**Board of Adjustment
Special Meeting Agenda
Fraser Town Hall, 153 Fraser Avenue
Wednesday February 26, 2025
5:30 PM - 6:30 PM**

a. Appeal Of Administrative Variance Denial - The Ascent

RE: The Ascent – Final Plat, Major Site Plan, Administrative Variance
Planning Review Comments (1st Referral Review)

SITE PLAN

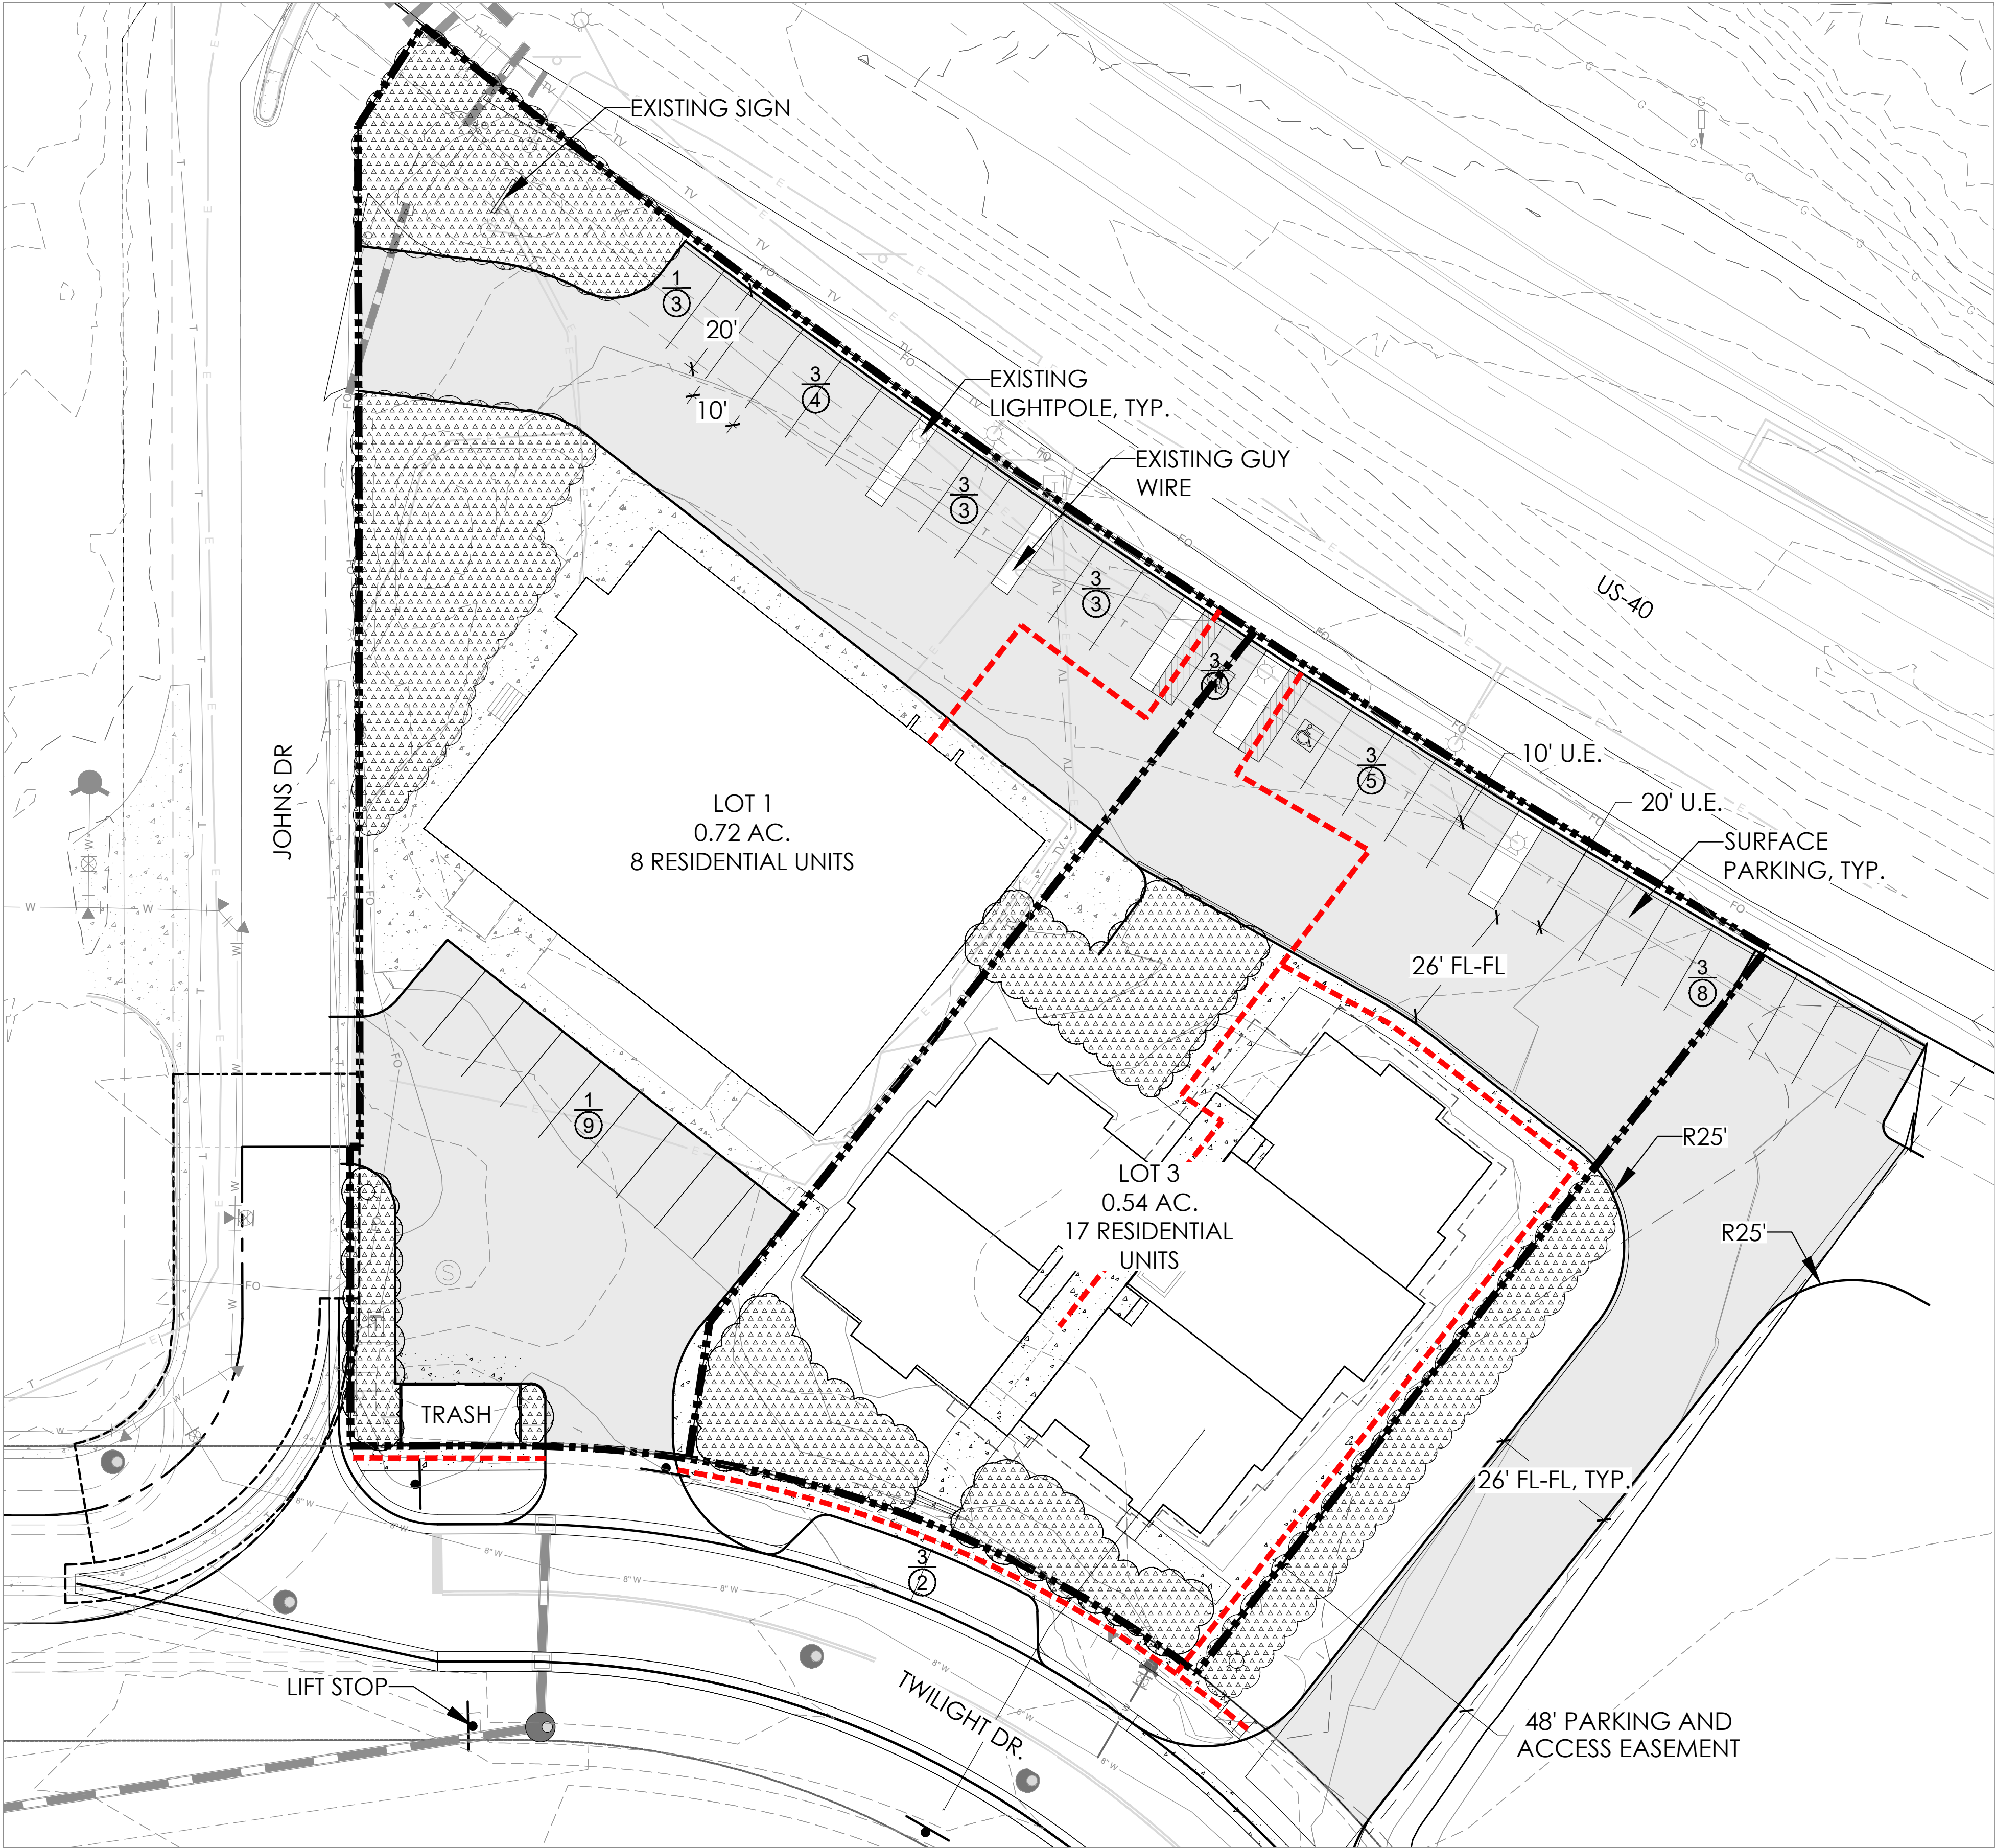
Sheet 2 – Site Plan

- 24) Provide a trash enclosure detail showing conformance with [Sec. 19-4-160\(b\)](#), i.e., label the enclosure color and materials to ensure they are consistent with those of the main building.

- 25) Include a summary of unit types by bedroom count or note that all units will be two-bedroom units.
- 26) Note or provide in the data table the number of bedrooms in the existing two units in the XSports building since there will be shared parking between the lots.

- 28) Please add a note that the two parallel spaces proposed along “Victory Rd” within the proposed ROW are included in the provided parking count.
- 29) Data table lists Lot 1A and 2B. Should be 1A and 1B unless the lots are renumbered to Lot 1 and Lot 3 as requested by staff.

- 30) Please remove floor plan linework from building footprints for clarity.
- 31) In September 2024, the Town adopted by reference the 2023 Colorado Model Electric Ready and Solar Ready Code. The site plan must display compliance with applicable requirements of this code before building permits are issued. Please designate on the parking plan at least a minimum number of EV spaces per the requirements below. Definitions for each category of EV capability are found in Chapter 2 of the referenced code. Multifamily residential is found on page 25 and must include the following:

LANDSCAPE PLAN

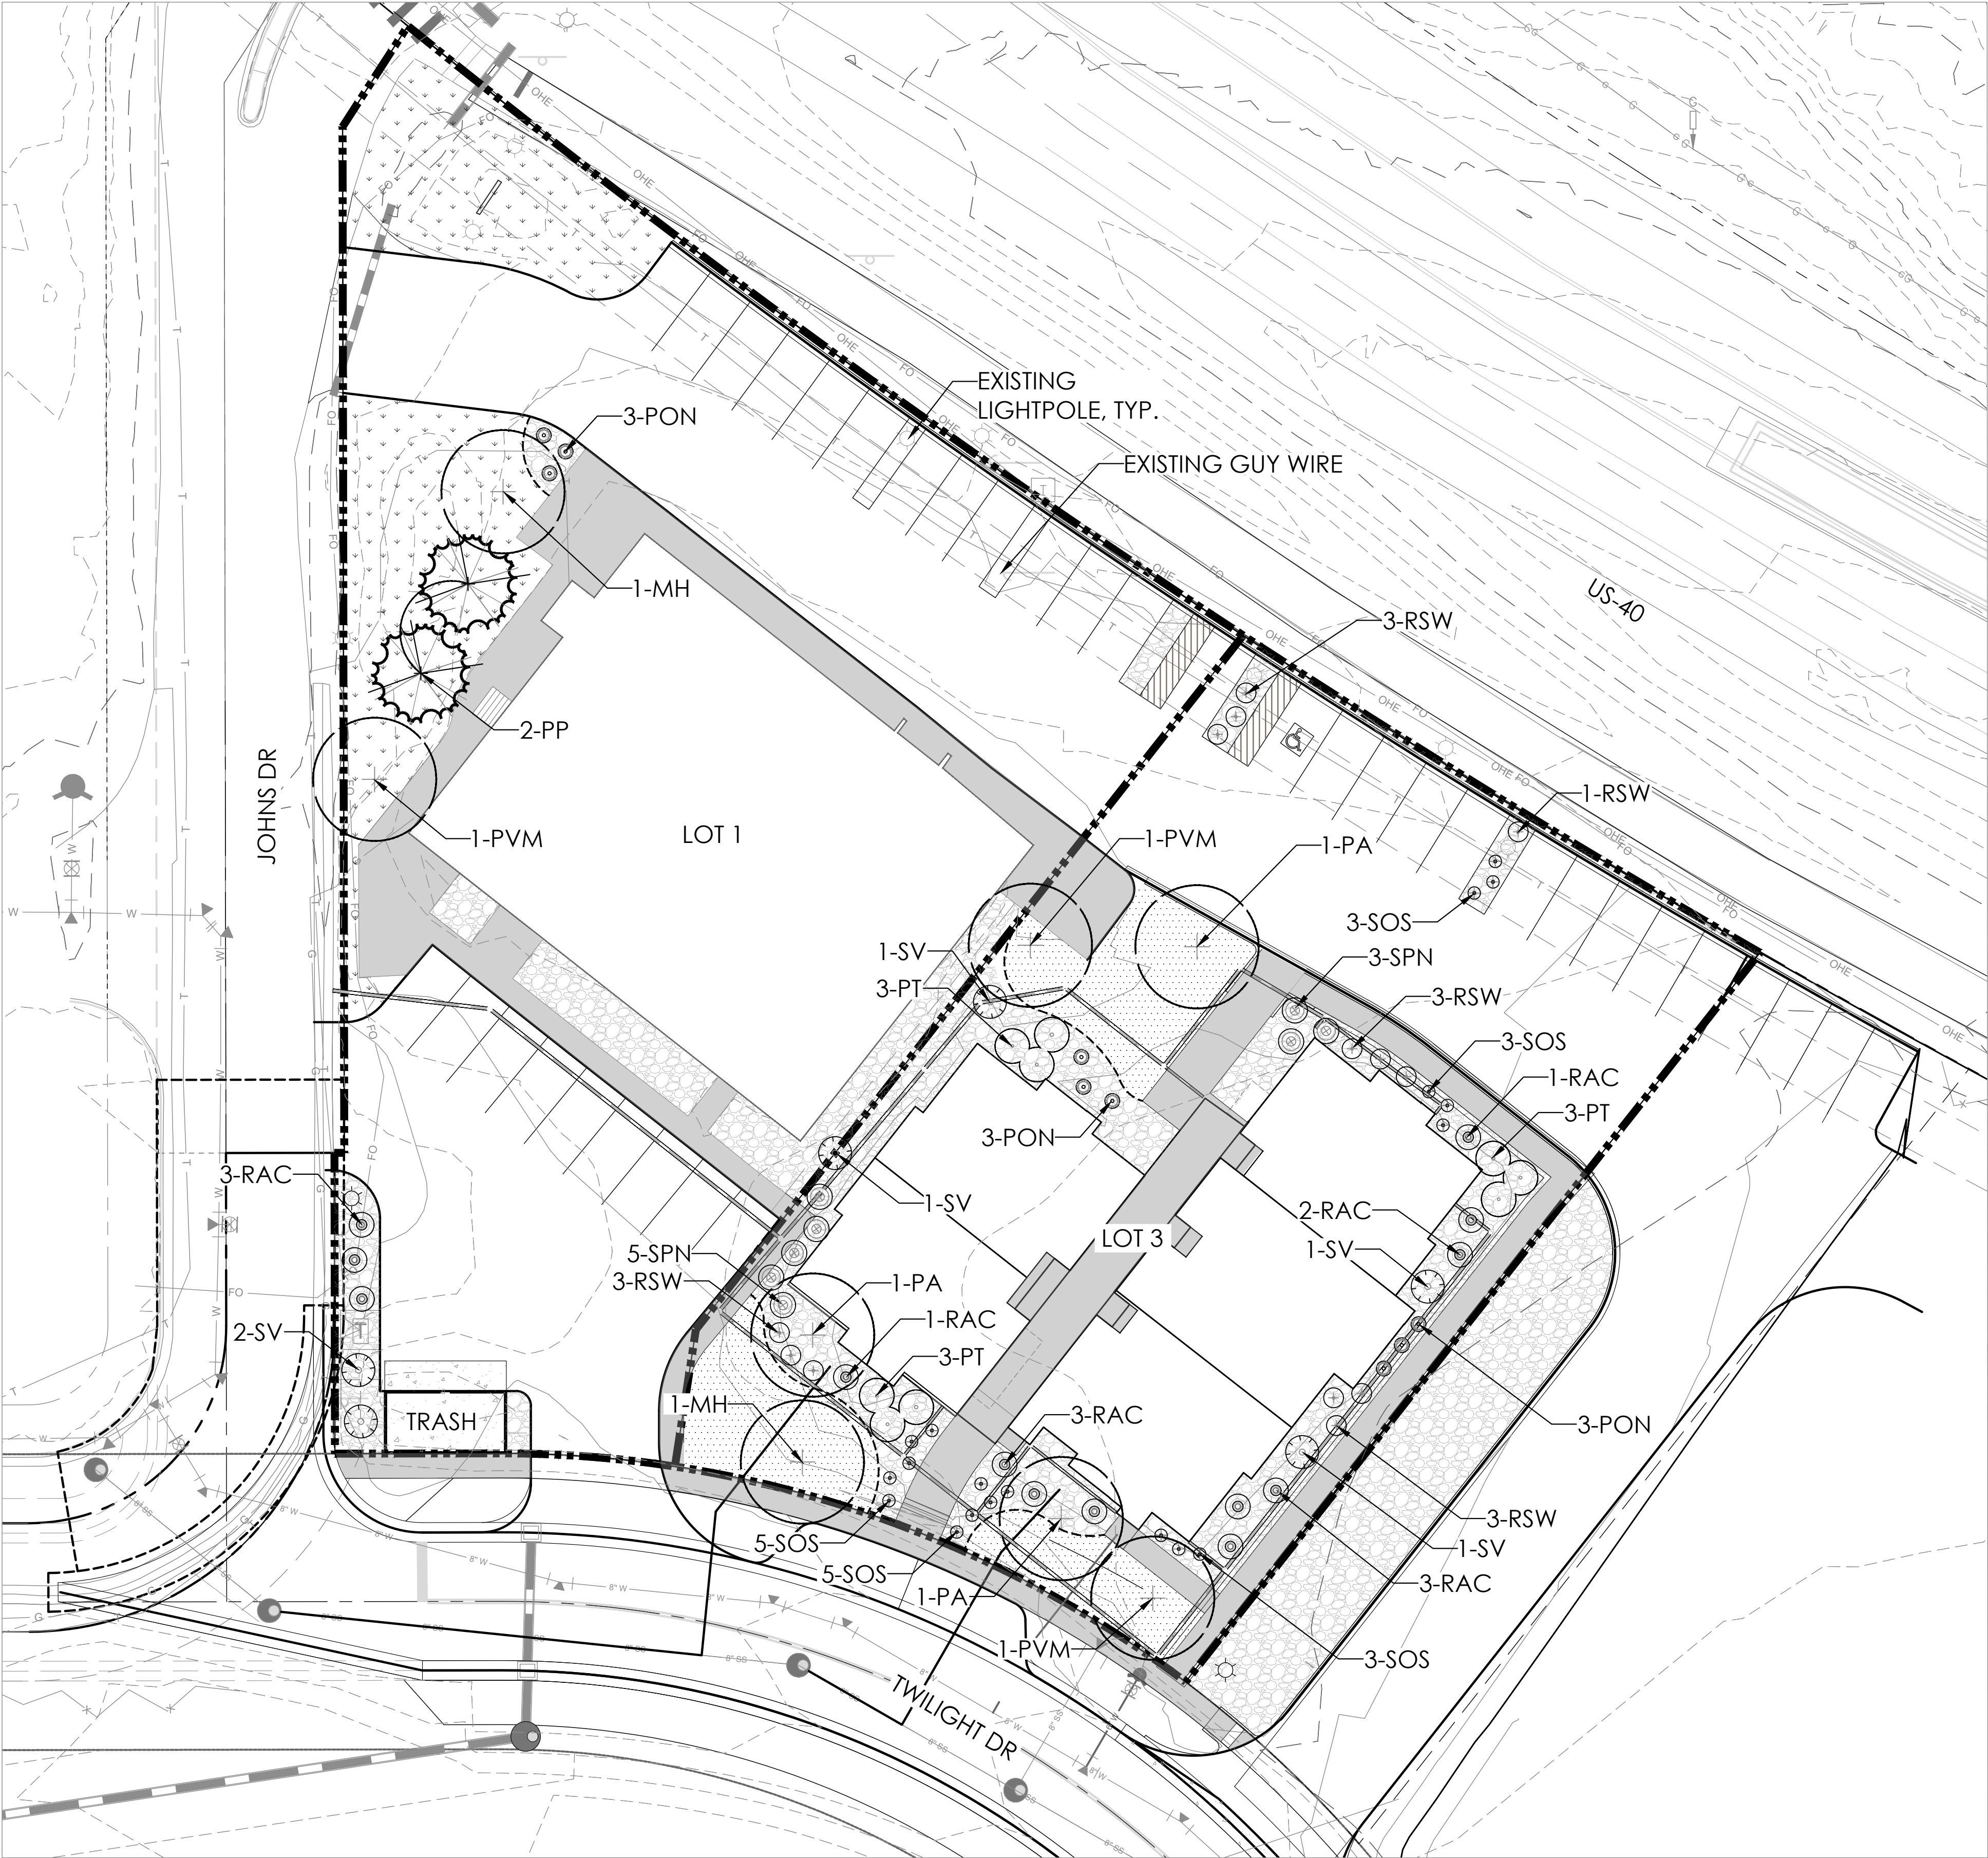
Sheet 3 – Landscape Plan

- 34) [Sec. 14-5-40\(10\)](#) requires parking lot interior landscaping islands for parking lots with twenty (20) or more parking spaces at a ratio of one hundred (100) square feet and one (1) tree and two (2) shrubs for every ten (10) parking spaces. Please provide additional interior landscaped islands within the parking area on the northeast side of the site, similar to the two that are proposed at either end of the southeast row of parking.

- 35) Provide the following as required in [Sec. 14-5-40](#) - landscaping specifications:
- a. Provide an irrigation plan, if irrigation is to be provided.

- b. Include a statement providing that the owner and his or her heirs, successors and assigns will provide adequate maintenance for all site elements. Landscaping maintenance shall include irrigation, fertilization, pruning and noxious weed control.

- c. Include contact information on who prepared the landscape design. A landscape plan drawn by a landscape architect or designer is preferred but is not required.

- 36) Please provide a cost estimate of the proposed landscaping subject to the following requirement from [Sec. 14-5-40\(11\)](#). This amount will need to be included in the collateral collected as part of the DIA:
